**SERVICE CAMPAIGN 75-11 Generator Door Panel Attachment
AFFECTED MODELS: 2022-2024 Journey**

Generator Door Panel Attachment

Field Service Campaign

Figure 6

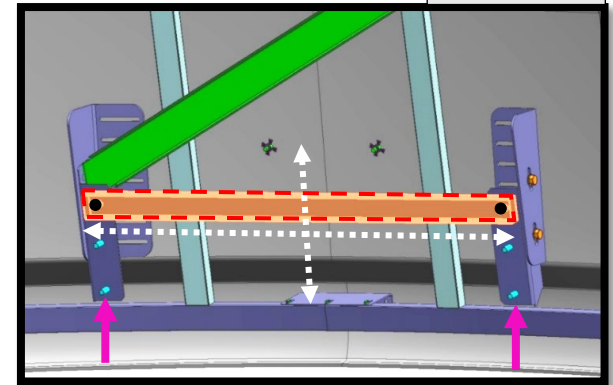
Step 5 – Install the New Tube 361293-01-01C Between the Two Mounting Plates

- A. Place the new tube in position (361293-01-01C) (See Figure 6 – Highlighted in Red dashes). It should be leveled and centered between the two mounting plates that have the weld studs installed.
- B. The distance from the top edge of the two mounting plates to the top edge of the bracket with weld studs is 10 mm. (See Figure 7)
- C. Using the holes in the new tube as a guide, drill 2 holes into the two mounting plates using a 5/16" drill bit. Do both sides of the tube. (See Figure 7 – Highlighted in a Yellow circle)
- D. Using a 1/2" backing wrench and a 1/2" size socket wrench, bolt the tube to the mounting plates using 000C26-05-24U bolts (2) with 000D29-05-00U nuts (2). (Figure 7-Yellow)

NOTE: Ensure that the connections between the new tube and the mounting plates are secured with a torque setting. Apply torque value of 100 in-lbs.

Figure 8

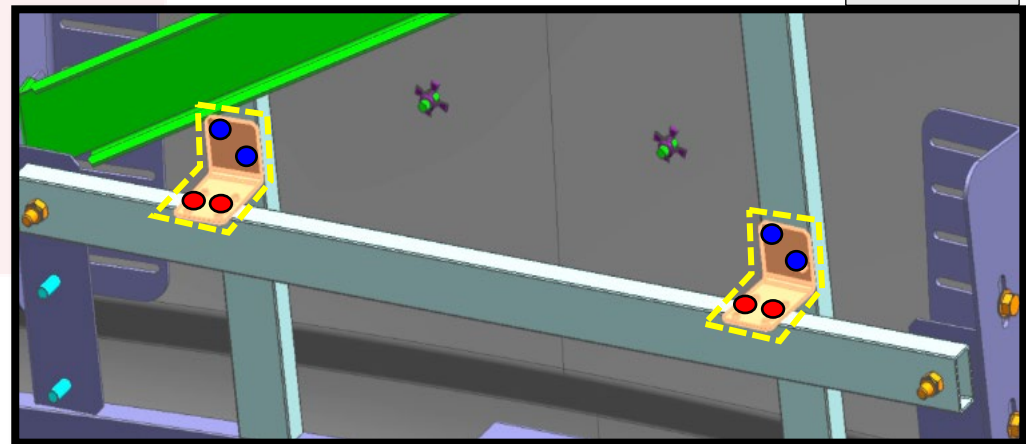
- E. Using 2 of the new 361203-01-01B brackets, connect the new tube to the existing frame structure using (4) 3/16" steel rivets (087718-01-000). (See Figure 8 – Yellow Dashes)
 - Use the bracket as a guide to drill out two holes in each of the 2 preexisting tubes using a 3/16" drill bit. (See Figure 8 – Highlighted in Red circles). Ensure to only drill through the first surface of the 2 preexisting tubes.
 - Without moving the new brackets from the holes, you just drilled, use the same drill bit to drill out 2 holes on the bottom side of the bracket that sits on the new tube (See Figure 8 – Highlighted in Blue circles)
 - Install (4) 3/16" steel rivets (087718-01-000), 2 on each preexisting tube.

Figure 10A

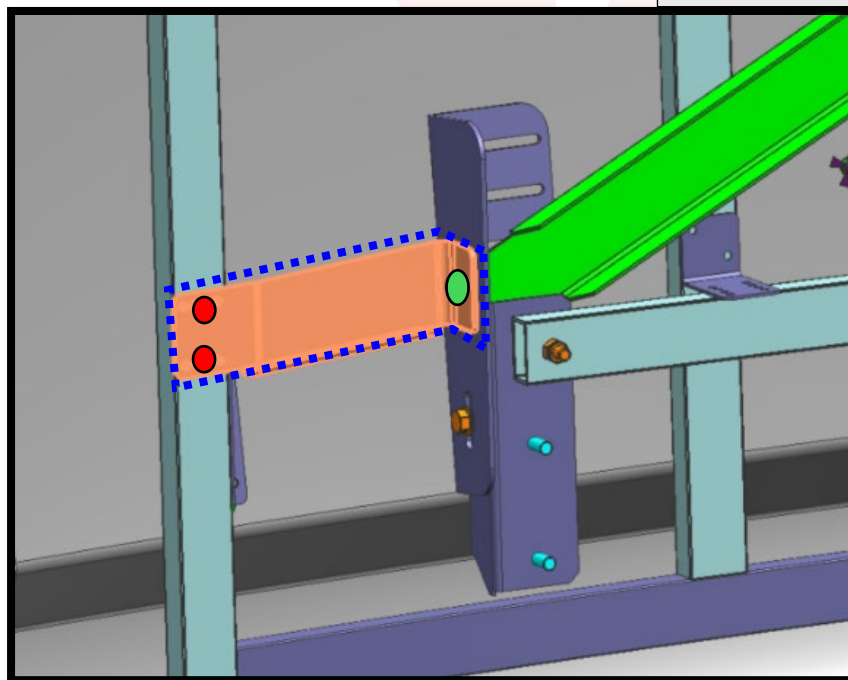
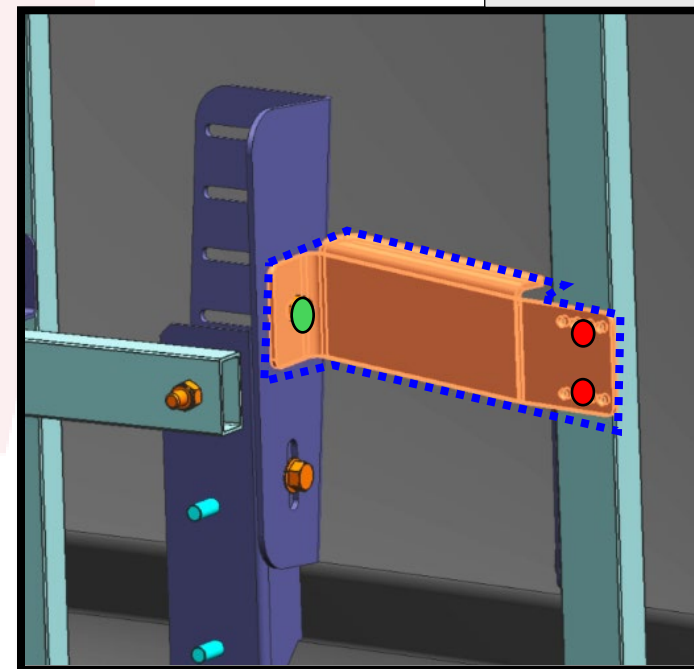
- A. Use a 1/2" backing wrench and a 1/2" socket and socket wrench to remove the upper bolt from each main mounting bracket and use these for the next step (B). (See Figure 9 – Highlighted in Red Circles)
- B. Re-bolt one of the new brackets (361202-01-01B) to each of the main mounting brackets (2) (See Figure 10A & 10B – Green Dots). The face of the bracket with rivet holes should sit flush with the frame assembly of the generator door. (See Figures 10A & 10B – Highlighted in Blue Dashes)

- C. Using the new bracket as a guide, drill 2 holes with a 3/16" drill bit into each tube. Install 3/16" steel rivets (087718-01-000) into each hole. (See Figure 7A & 7B – Reference the Red Dots for Hole & Rivet Locations)

NOTE: For the upper support arms, secure the 5/16" fasteners with a torque setting of 157 in-lbs. Care should be taken to avoid over-tightening, which can affect the integrity of the fiberglass hood.

Figure 11

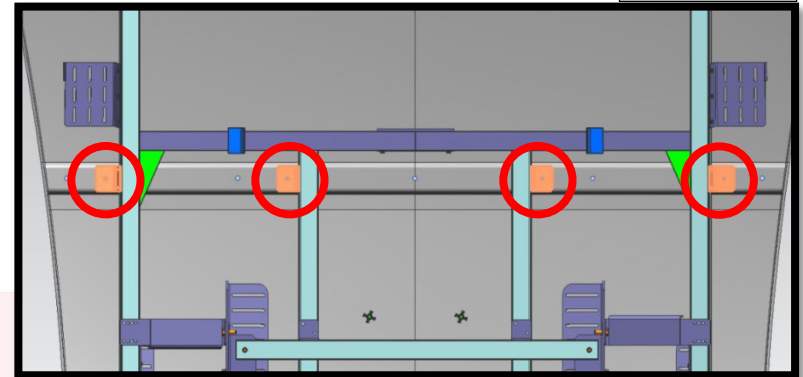
Step 7 – Connect the Frame Assembly to the Fiberglass Using 4 of the New Brackets 361200-01-01B (Figure 11)

- A. Trim away foam around the area where the 4 new brackets will be placed. (See Figure 11 – Highlighted in Red Circles)
- B. Place the new brackets so that they are flush with the vertical generator door frame tubes and center the brackets on the raised molded feature in the fiberglass. (See Figure 12- Highlighted in Yellow)

- C. While ensuring the bracket stays in place, use the larger hole and a 5/16" drill bit to drill a hole through the fiberglass.
- D. Use the 4 new 1/4" bolts, the 4 nyloc nuts and the 4 washers to bolt the new brackets to the fiberglass (the 5 preexisting holes are for the trim strip and the 4 new bolts from the rework kit are for the 4 brackets) (See Figure 11 – 4 Red Circles).

NOTE: The 4 - 1/4" fasteners going through the fiberglass hood (5 existing for the trim strip and 4 new from the rework) must be torqued hand tight only. Excess torque can lead to cracking in the fiberglass.

NOTE: Only torque hand tight, excess torque can cause the fiberglass to crack. Do NOT use a drill!

Figure 14

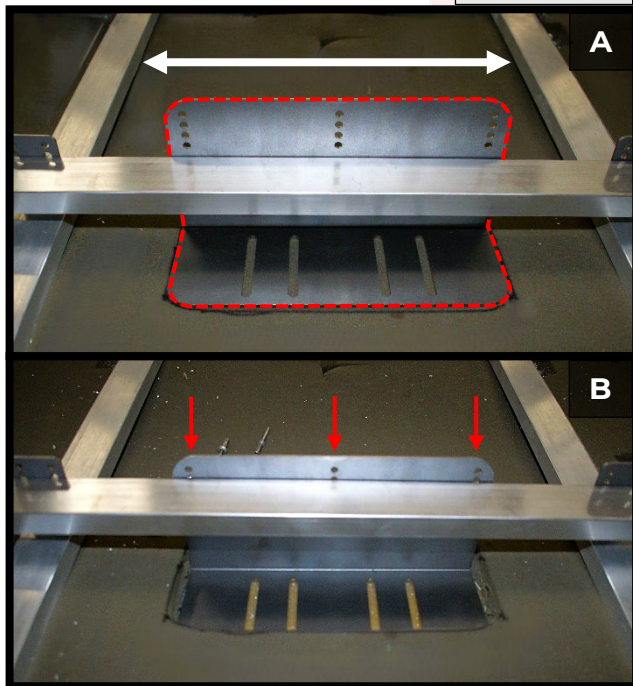
- A. Take the new bracket 361201-01-01B and place it as shown below (See Figure 14A – Outlined in Red Dashes).
- The bracket should be flush with the top face of the new tube and centered between the two vertical tubes of the existing frame assembly.

- B. Using the new bracket as a guide, drill 3 holes with a 3/16" drill bit into the new tube on the top surface. (See Figure 14B – Red Arrows)
- C. Using the provided Plexus MA300 adhere the bracket to the fiberglass ensuring that the bracket is centered and flush with the top face of the new tube. The Plexus must ooze out through the bracket slots. (See Figure 15)

Figure 19

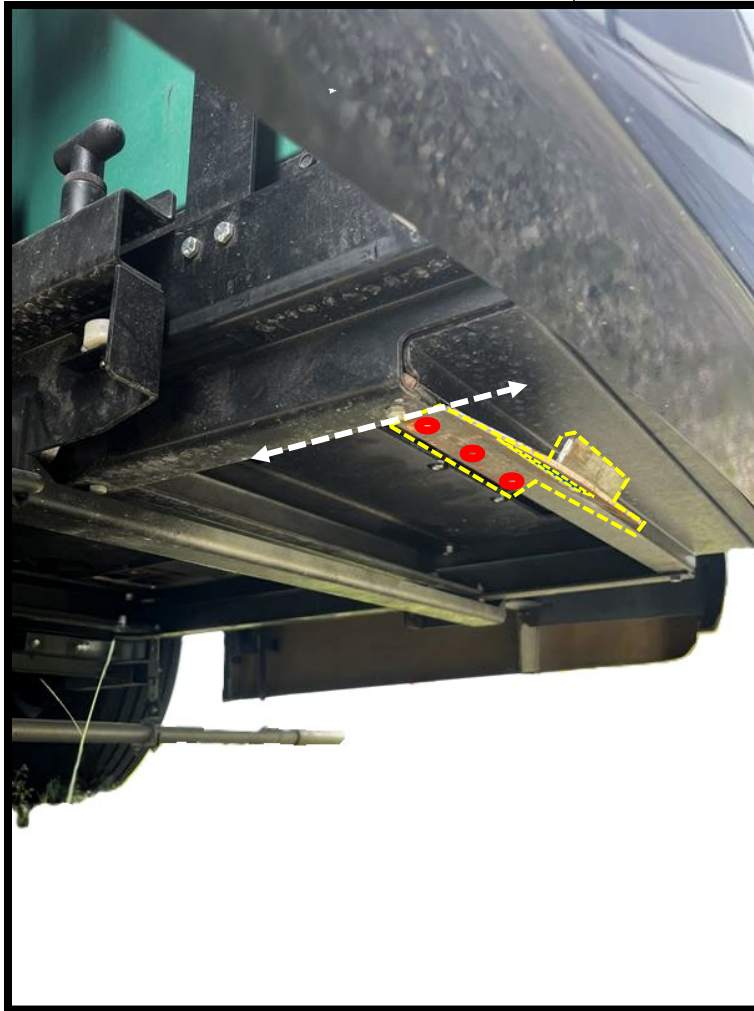
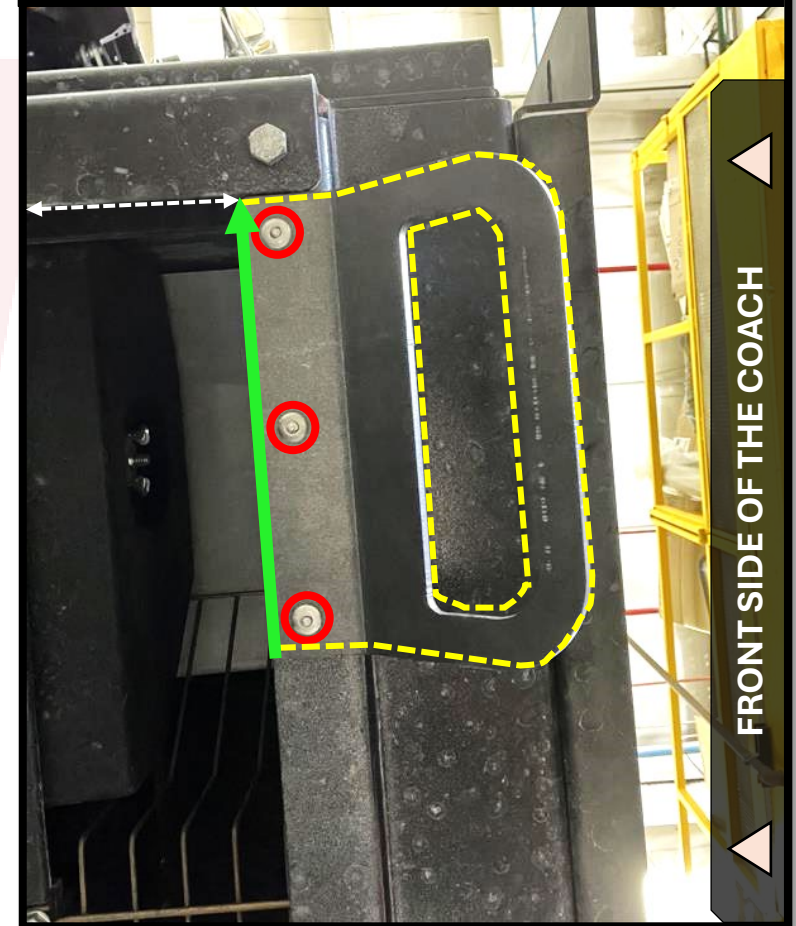
Step 9 - Install the New Pull Handle 361201-01-01B.

- Align the bracket with the flange on the generator slide (See Figure 19 – White Dashed Double headed Arrow). The bracket should be angled down and as far to the passenger side as possible. (See Figure 20 – Green Arrow)
- Using the new bracket as a guide, drill three holes with a 3/16" drill bit through the flange.
- Install 3/16" steel rivet 087718-01-000 into each hole. (See Figure 20 – Red Circles)
